**GOVERNMENT OF THE DISTRICT OF COLUMBIA
DEPARTMENT OF TRANSPORTATION**

MEMORANDUM

SUBJECT: ZC Case No. 08-07C – Reunion Square Building 4

Figure 1 – Site Access and Circulation (Source: CTR, Gorove/Slade, Figure 8, 6/11/18)

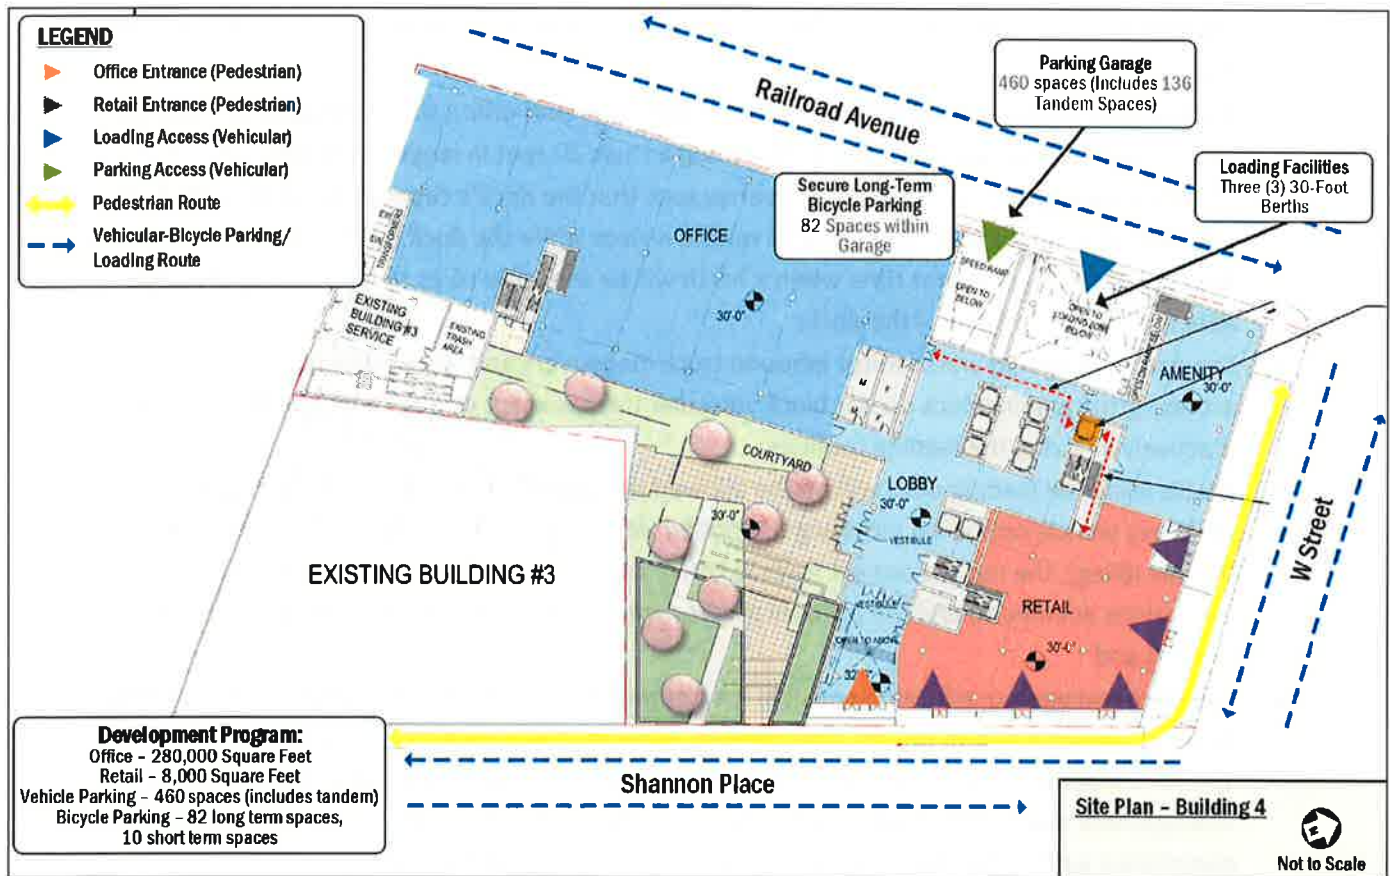
- A 79 ½-foot curb cut is proposed on Railroad Avenue to serve the parking garage and loading area. Per the DDOT Design and Engineering Manual (DEM) the curb cut should be a maximum of 24 feet wide with a 12-foot pedestrian refuge between the two entrances;

The parking garage entrance and loading facilities are proposed from Railroad Avenue SE which is a 30-foot wide street located at the rear of Building 4. Pedestrian entrances for both office and retail uses are located on W Street and Shannon Place. The Applicant is proposing to close a net total of three (3) existing curb cuts on W Street and Shannon Place. Additionally, two (2) existing curb cuts will be closed and relocated on Railroad Avenue. Figure 1 below shows the site layout of Building 4.

Figure 7 – Expected Future Pedestrian Infrastructure (Source: CTR, Gorove/Slade, Figure 27, 6/11/18)

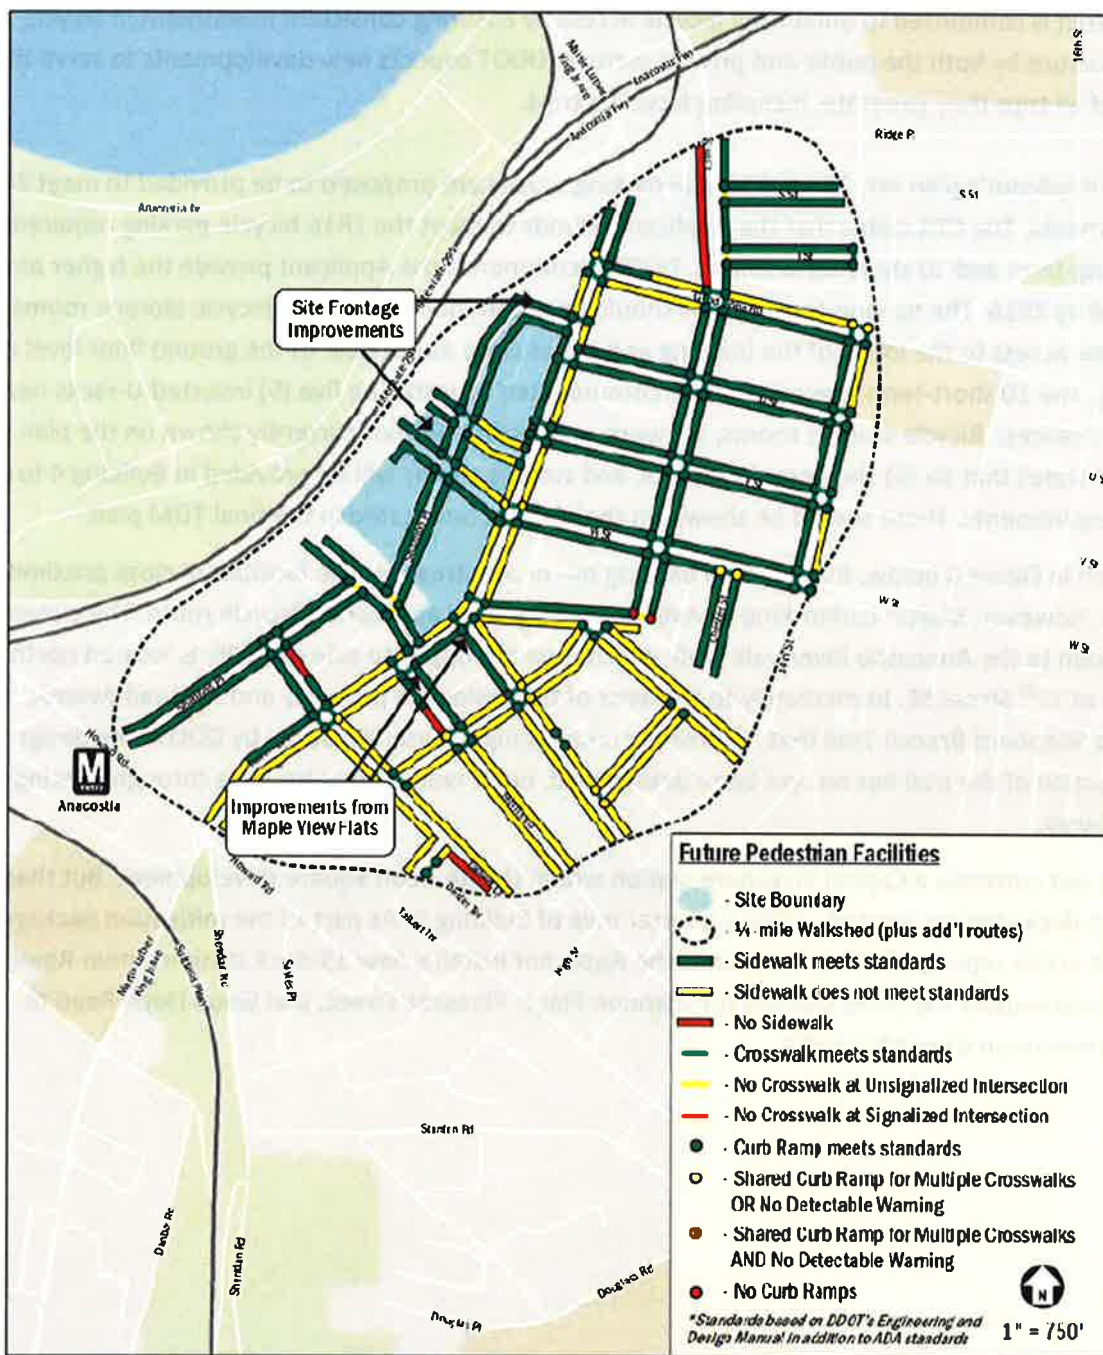
The CTR’s inventory of pedestrian infrastructure, as shown in Figure 7 below, demonstrates that most sidewalks and curb ramps in the vicinity of the site are currently consistent with DDOT standards. While there are a few missing or substandard segments of sidewalk and curb ramps in the broader area, the existing pedestrian network along major pathways to schools, attractions, and the Metrorail station is generally adequate. There is a missing link of sidewalk along the northern side of Talbert Street just to the south of the site. This segment of sidewalk should be constructed in conjunction with other improvements, as noted elsewhere in this report, to improve pedestrian connectivity in the study area and to offset traffic impacts from site generated traffic.

Additionally, the Martin Luther King Jr. Avenue SE corridor is planned as part of the Great Streets Initiative to have bulb-outs installed along the eastern side. These bulb-outs would shorten the crossing distances for pedestrians, better delineate on-street vehicle parking, and slow vehicles turning onto side streets. Bulb-outs should be installed at Morris Road SE, Maple View Place, Pleasant Street, W Street, V

Street and U Street to encourage walking to and from the site and to help mitigate the impacts from site-generated traffic.

- Bulb-outs on the east side of Martin Luther King Jr Avenue at Morris Road, Maple View Place, Pleasant Street, W Street, V Street and U Street, consistent with the recommendations of the Great Streets Initiative; and
- A 6-foot sidewalk along the north side of Talbert Street SE between Shannon Place and the public alley.

Figure 8 – Existing and Proposed Bicycle Facilities (Source: CTR, Gorove/Slade, Figure 28, 6/11/18)

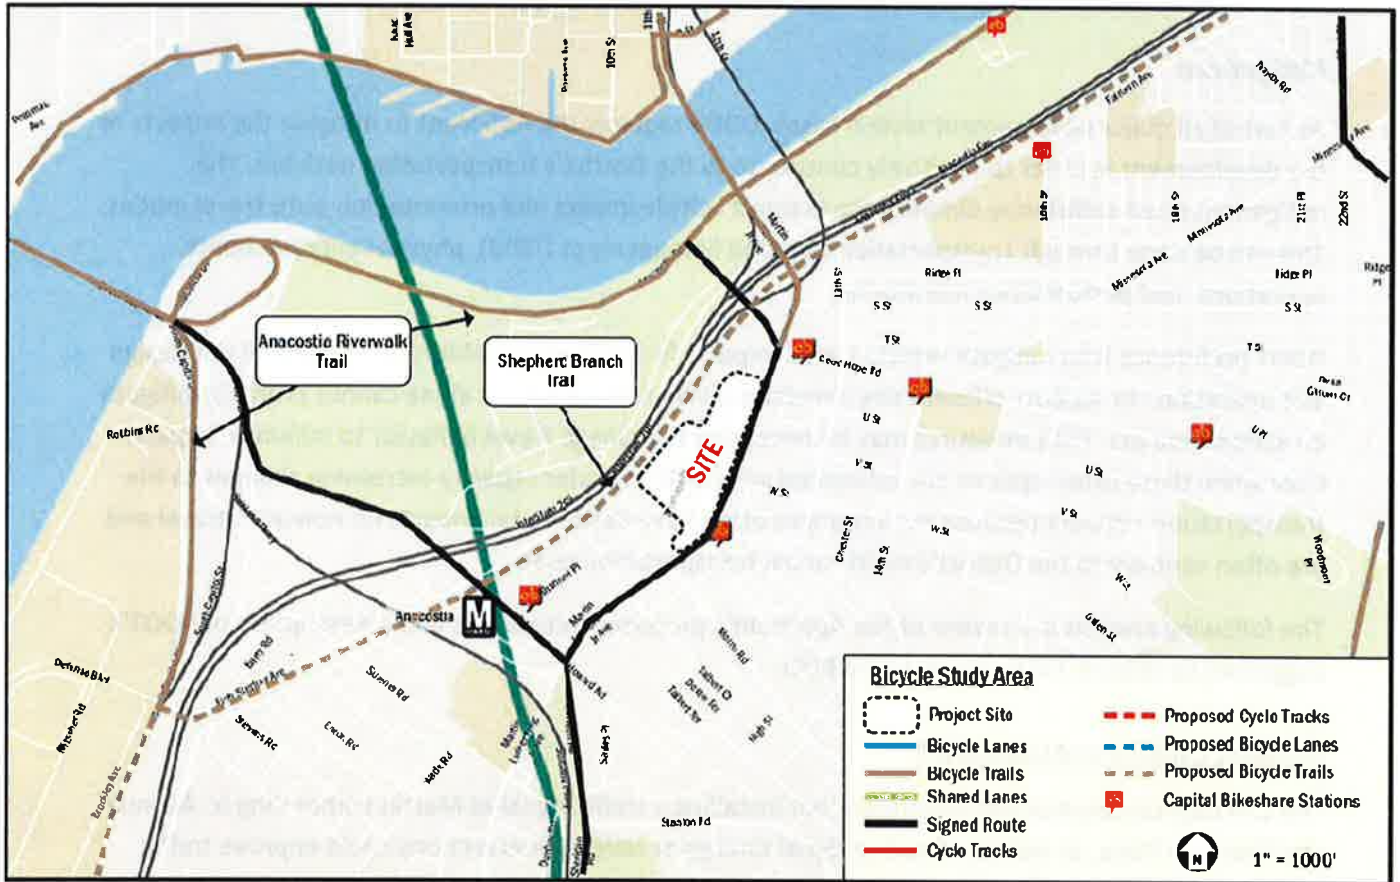
As shown in Figure 8 below, there are no existing on- or off-street bicycle facilities in close proximity to the site. However, Martin Luther King Jr. Avenue is designated as a signed bicycle route. The closest connection to the Anacostia Riverwalk Trail, which is on the opposite side of I-295, is located north of the site at 11th Street SE. Immediately to the west of the Building 4 property and Railroad Avenue is the planned Shepherd Branch Trail that is currently undergoing a feasibility study by DDOT. The design and final location of the trail has not yet been determined, but it would likely traverse through existing CSX right-of-way.

There is not currently a Capital Bikeshare station within the Reunion Square development. But there are three 11-dock stations located within a quarter mile of Building 4. As part of the mitigation package outlined in this report, DDOT recommends the Applicant install a new 19-dock station within Reunion Square and expand the three stations on Shannon Place, Pleasant Street, and Good Hope Road to DDOT's minimum size of 19-docks.
